Indeck Wharton, LLC

Submission of additional Information to US EPA – Region 6

Based on Communication from Jennifer Huser, US EPA,
on Wednesday, January 22, 2014

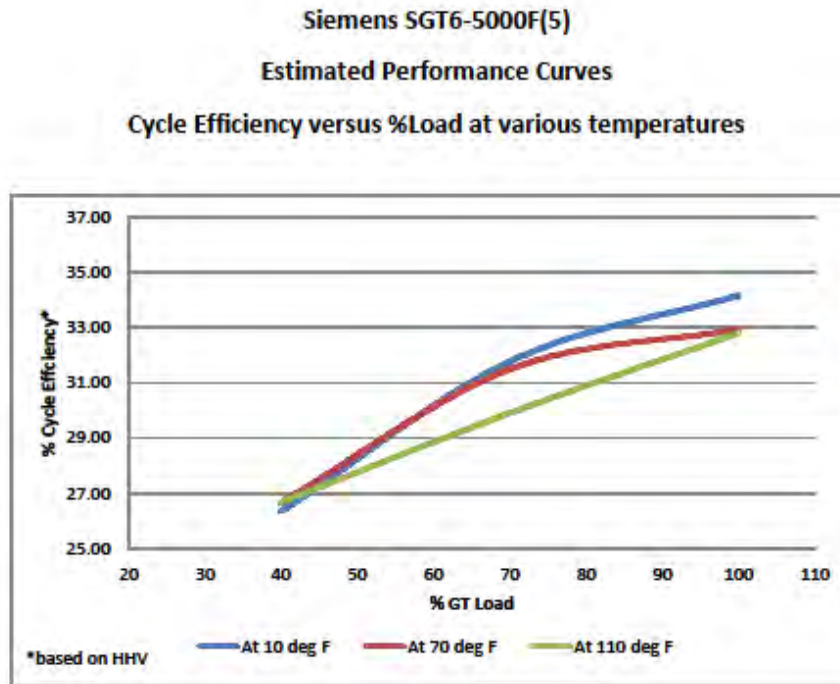
6. Please provide any simulation run data that has been provided by the turbine manufacturers that was used to support the emissions and/or BACT level calculations. For your reference, an example is provided below.

Manufacturer’s data is attached. This is also provided in the TCEQ application materials that have been forwarded.

GE 7FA
Estimated Performance Curves
Cycle Efficiency versus %Load at various temperatures

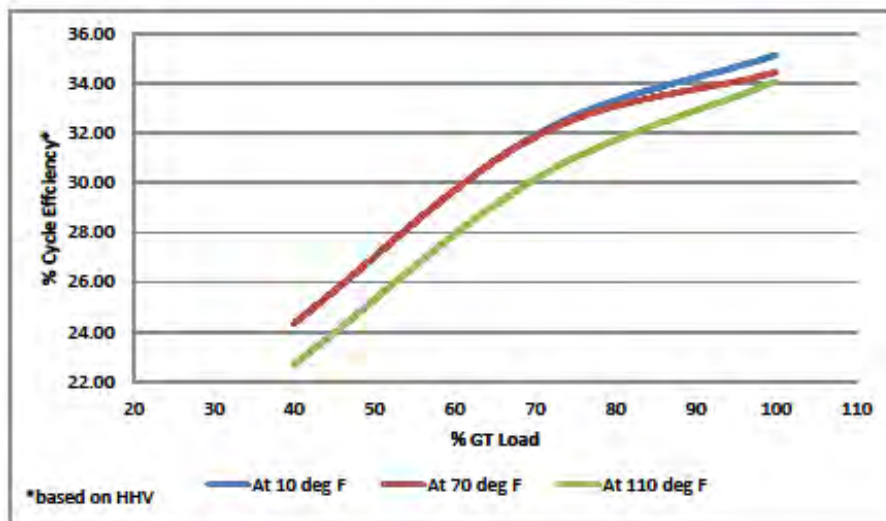
Efficiency Graphs

Indeck has prepared efficiency graphs versus load for both the GE and Siemens units. They are provided as follows:

Temperature	X axis	Y Axis
	Load	Efficiency
10	100	35.14
10	70	31.91
10	40	24.35
70	100	34.44
70	70	31.85
70	40	24.35
110	100	34.09
110	70	30.15
110	40	22.70
